49 E 1st AVENUE (COMPLETE APPLICATION)
DE419622 - CD-1 (612)

DEVELOPMENT PERMIT STAFF COMMITTEE MEMBERS

DEVELOPMENT PERMIT STAFF COMMITTEE RECOMMENDATION: APPROVE

Date: AUG-24-2015	Project No: 13078
Scale: 1/8" = 1'-0"	Drawing No:
Drawn By: RHC	L-13
The name:

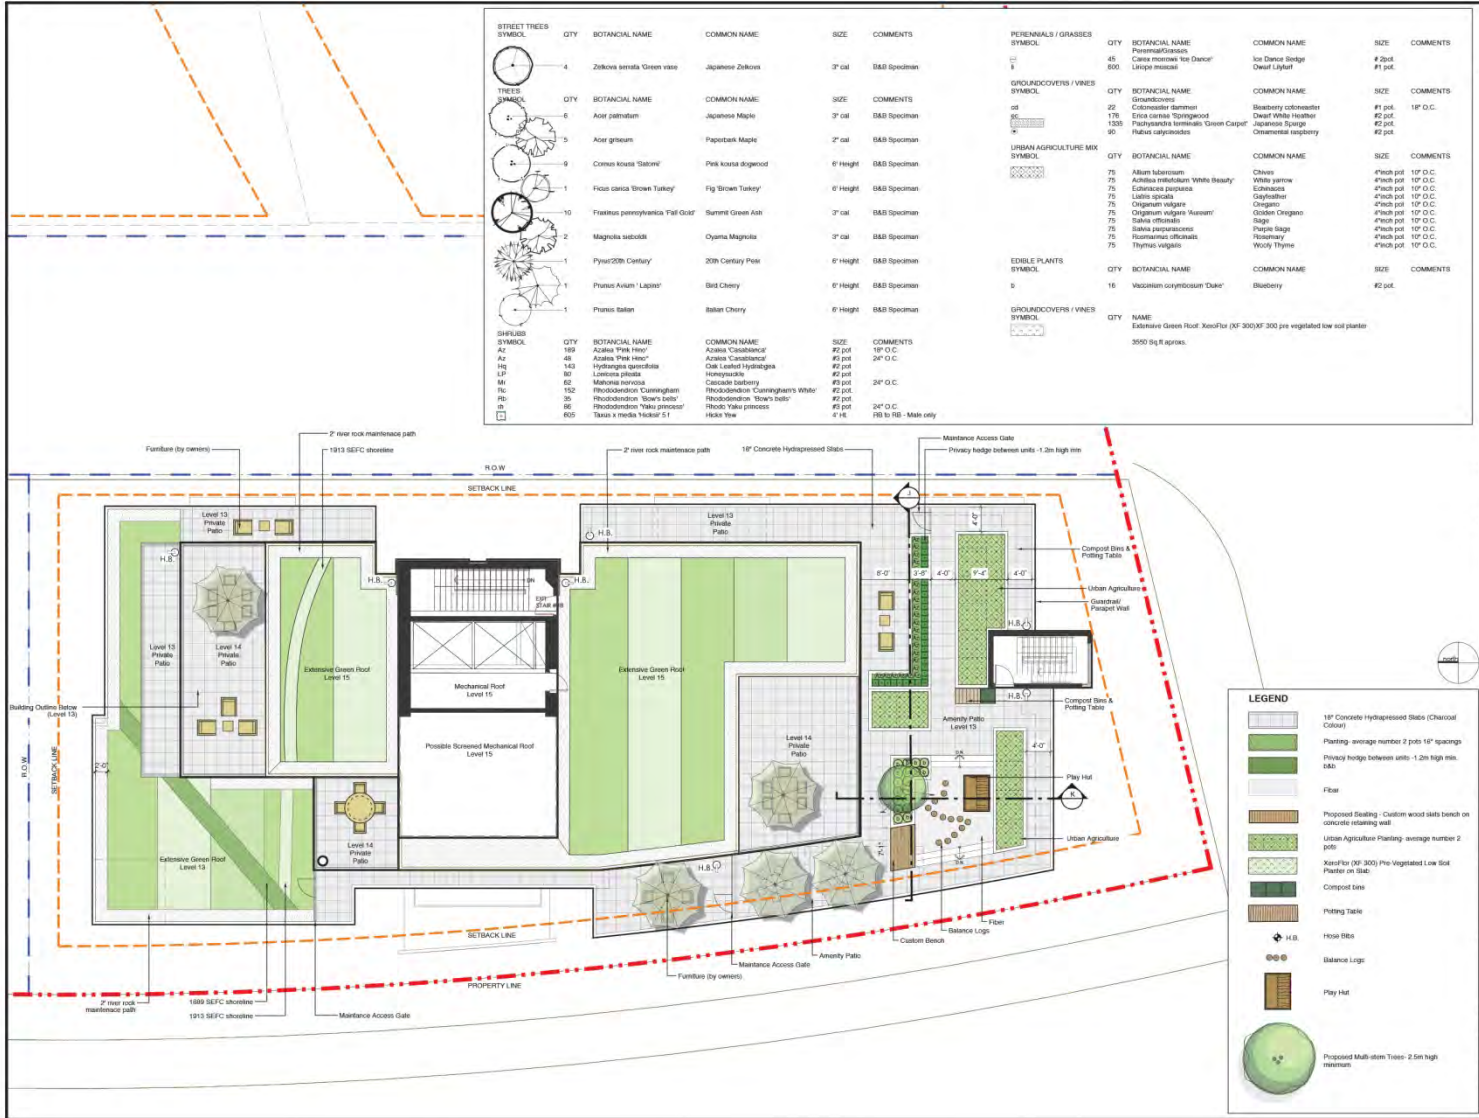
- Remove the note on drawing L-1.2 that indicates 3 bike racks located in the landscaped area near the intersection of Pullman Porter Street and the pedestrian walkway, north of the loading bay.
- Provision of plant material behind the benches proposed on East 1st Avenue that will not grow to 8 feet tall and encroach onto the benches.
